**Metro Manila Subway Project Phase 1
PACKAGE CP104: (ORTIGAS NORTH AND ORTIGAS SOUTH)**

ITEM NO.	REFERENCE/CLAUSE/SECTION	QUERIES	RESPONSE
----------	--------------------------	---------	----------

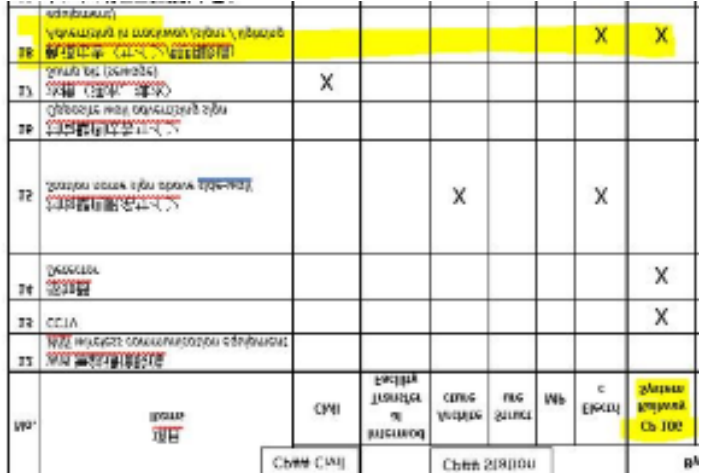
199.	Additional Concrete between the Staircases and the Escalators DWG Nos. STN-AR-A-OS/ON-9191 Upstand concrete wall indicated in 3 SECTION-3 and 5 DETAIL-B	Please provide details such as rebar and concrete strength fir t We cannot also find any pay items for material nos. 11, 14, 19 and 21 in BOQ. Kindly provide the pay items and quantities for the above works in Bill No. 4 after you have provided answers for the above clarifications.	Item 11 is included in Pay Item No. 1018 (3) a1 <table border="1" style="width: 100%; border-collapse: collapse;"> <tr> <td style="width: 10%; text-align: center;">1018</td> <td style="width: 10%; text-align: center;">1018 (3) a1</td> <td style="width: 80%;">Granite Stone Honed Finish – 600x1200</td> </tr> </table> Item 19 is included in Pay Item No. 1803 (3) a <table border="1" style="width: 100%; border-collapse: collapse;"> <tr> <td style="width: 10%; text-align: center;">1803</td> <td style="width: 10%; text-align: center;">1803 (3) a</td> <td style="width: 80%;">Stainless Steel Cover in between Stair and Escalator</td> </tr> </table> Item 14 & 21 is included in Pay Item Nos. 1018 (3) a1 & 1018 (3) a2 <table border="1" style="width: 100%; border-collapse: collapse;"> <tr> <td style="width: 10%; text-align: center;">1018</td> <td style="width: 10%; text-align: center;">1018 (3) a1</td> <td style="width: 80%;">Granite Stone Honed Finish – 600x1200x30</td> </tr> <tr> <td style="text-align: center;">1018</td> <td style="text-align: center;">1018 (3) a2</td> <td>Granite Stone Honed Finish – 1200x150x30</td> </tr> </table>	1018	1018 (3) a1	Granite Stone Honed Finish – 600x1200	1803	1803 (3) a	Stainless Steel Cover in between Stair and Escalator	1018	1018 (3) a1	Granite Stone Honed Finish – 600x1200x30	1018	1018 (3) a2	Granite Stone Honed Finish – 1200x150x30

1018	1018 (3) a1	Granite Stone Honed Finish – 600x1200													
1803	1803 (3) a	Stainless Steel Cover in between Stair and Escalator													
1018	1018 (3) a1	Granite Stone Honed Finish – 600x1200x30													
1018	1018 (3) a2	Granite Stone Honed Finish – 1200x150x30

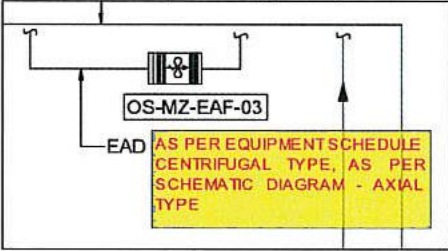
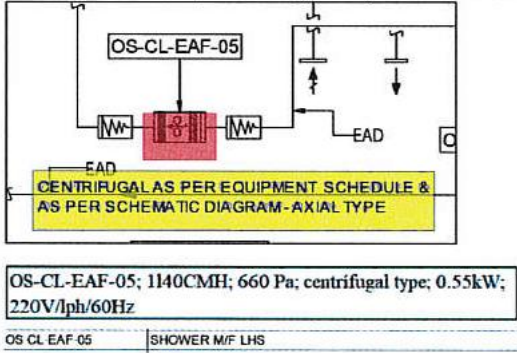
259.	STN-MEP-PLD-OS-5301 Bill of Quantities, Bill 5B, Item 1201 (3)	Please verify the TDH to be used for the Sewage Ejector Pit (OS-MZ-SP-03&04). Based on equipment schedule it is 35meters while on BOQ it is 30meters	35m shall be used

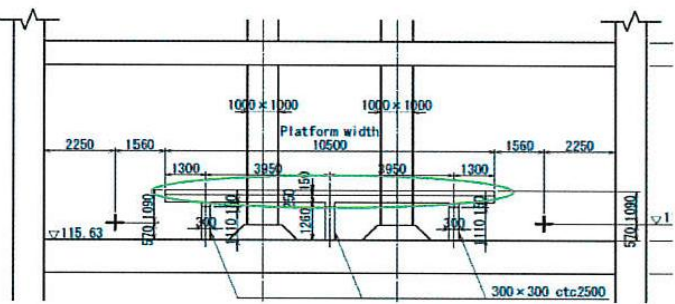
ITEM NO.	REFERENCE/CLAUSE/SECTION	QUERIES	RESPONSE																								
284.	Bill of Quantities, Bill 5A, Item 1215 (1) STN-MEP-VAC-ON-5101 to STN-MEP-VAC-ON-5108	Please verify which will prevail for AHU-Chilled type

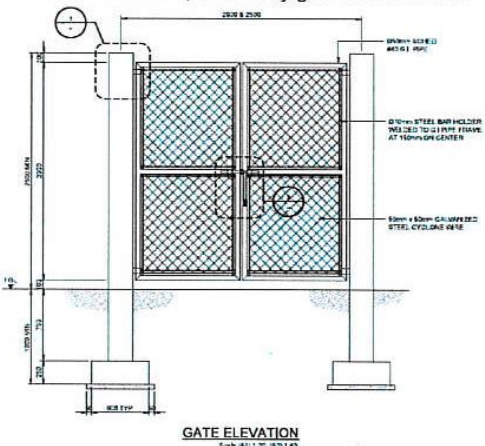
ITEM NO.	REFERENCE/CLAUSE/SECTION	QUERIES	RESPONSE																																																																																												
285.	Bill of Quantities, Bill 5A, Item 1216 (2), Item 1216 (3) STN-MEP-VAC-ON-5101 to STN-MEP-VAC-ON-5108	<p>Please verify which will prevail for Fans</p>

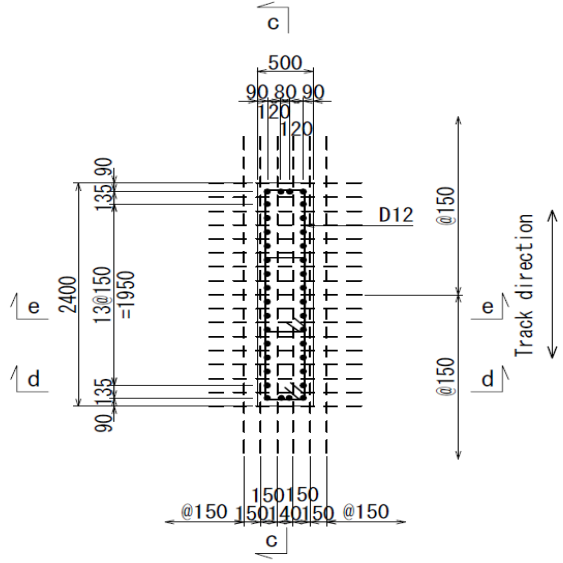
289.	Bill of Quantities, Bill 5A and Bill 5B Item 1202 (5) STN-MEP-FPS-CWD-1203	Please clarify if the Sprinkler Head (Pendent and Sidewall) is Quick Response or Standard Response, because it is not specified in Technit Specification, Plan and BOQ.	Sprinkler Head is Standard Response.

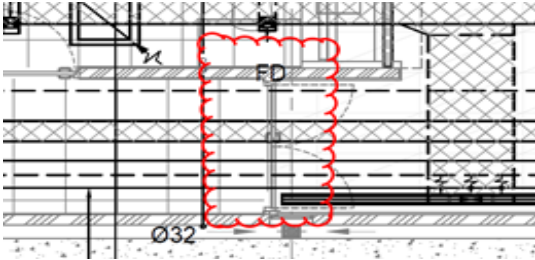
291.	Pay Item 604 Fencing Reference Drawing: SPL-C-F-ON-1013 SPL-C-F-OS-1013	The legend indicated in the Ortigas North Station plan is Pink for "FENCE TYPE-1" and Blue for "FENCE TYPE-2" while in the Ortigas South Station plan, Pink is for "FENCE TYPE-2" and blue is for "FENCE TYPE-1". May we know if this labelled correctly?	We confirm that drawings are labeled correctly. Kindly refer to fence type number instead.

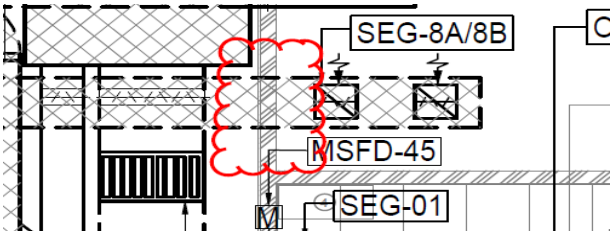
294.	STN-CE-OS-0040 (Column Stirrups)	Are the stirrups in this drawing two overlapping stirrups of the same size or is it a pair of one larger outer stirrup and one smaller inner stirrup?	Two overlapping stirrups of the same size

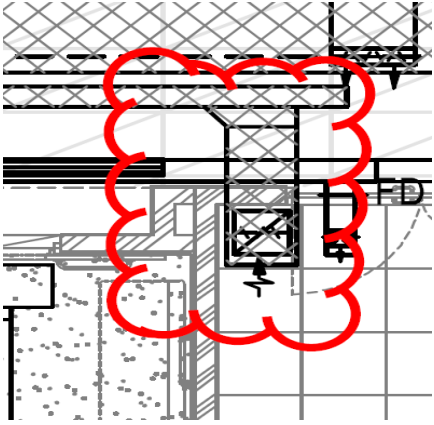
299.	Ortigas North Station	Please confirm if there is no Motorized Fire Damper on	Bidders to refer to the schematic diagram. For Schematic

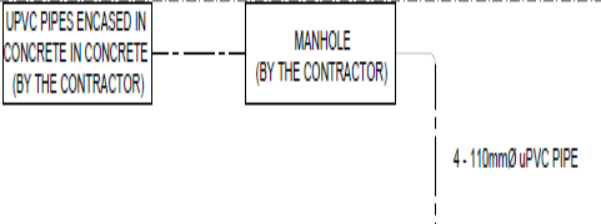
308.	STN-AR-A-ON-9671, STN-MEP-VAC-ON-3812	In reference with the Elev-02 North Station, kindly indicate the correct indication on which are the front and rear panel	Bidders to coordinate with Architectural and Civil drawings.
309.	SPL-E-ON-5041	Upon review of the bid plans, we found that there is no indicated dimensions of the handhole. We would like to request for the dimensions.	Handhole sizes varies and shall be calculated based from the number and sizes of the duct banks indicated in the design. Sizes of duct banks shall be referred in SPL-E-ON-5042.
310.	SPL-E-ON 5043	Upon review of the bid plans, we found that there is no indicated height of the equipment pedestal. We would like to request for the dimensions.	Please refer to note indicated in SPL-E-ON 5043, "Elevation of Concrete Pedestal is 900mm (minimum) or plus 10% of Ondoy Level, whichever is higher".

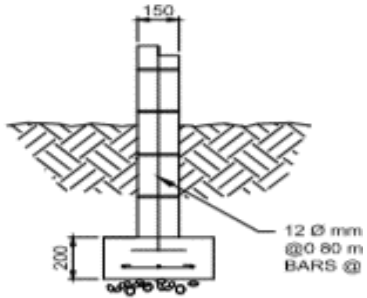
315.	DRG No. STN-MEP-ELV-ON-2044, DRG No. STN-MEP-ELV-ON-2048	<p>Please provide details for the manhole of Telephone and Data System.</p>	Contractor to provide in the shop drawing.

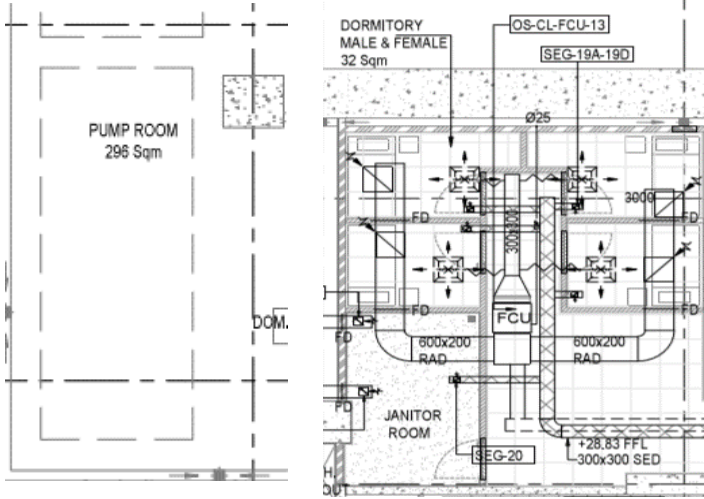
335.	DRG No. STN-MEP-ELV-ON-2044, DRG No. STN-MEP-ELV-ON-2048	Please provide details for the manhole of Telephone and Data System.	Contractor to provide in the shop drawing.

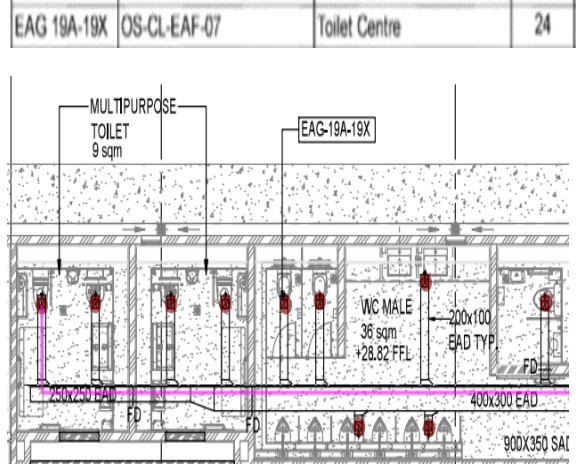
342.	STN-MEP-VAC-OS-5105 STN-MEP-VAC-OS-3121	Please Verify the Location of EAG 2 & EAG 3 since it does not reflect in the plan lay-out	Bidder to refer to the schematic diagram. This point is not a blocking point for bidding.

ITEM NO.	REFERENCE/CLAUSE/SECTION	QUERIES	RESPONSE								
		<table border="1" style="width: 100%; border-collapse: collapse;"> <tr> <td style="width: 15%;">EAG 2</td> <td style="width: 30%;">OS-MZ-EAF-1A/1B</td> <td style="width: 45%;">Janitor Platform</td> <td style="width: 10%; text-align: center;">1</td> </tr> <tr> <td>EAG 3</td> <td>OS-MZ-EAF-1A/1B</td> <td>Pump Room Platform</td> <td style="text-align: center;">1</td> </tr> </table> 	EAG 2	OS-MZ-EAF-1A/1B	Janitor Platform	1	EAG 3	OS-MZ-EAF-1A/1B	Pump Room Platform	1	
EAG 2	OS-MZ-EAF-1A/1B	Janitor Platform	1								
EAG 3	OS-MZ-EAF-1A/1B	Pump Room Platform	1								
343.	STN-MEP-VAC-OS5105 STN-MEP-VAC-OS-3111	Please verify tagging for Air Terminal EAG 22 to EAG 38 since it does not reflect in the plan lay-out.	Bidder to refer to the schematic diagram. This point is not a blocking point for bidding.
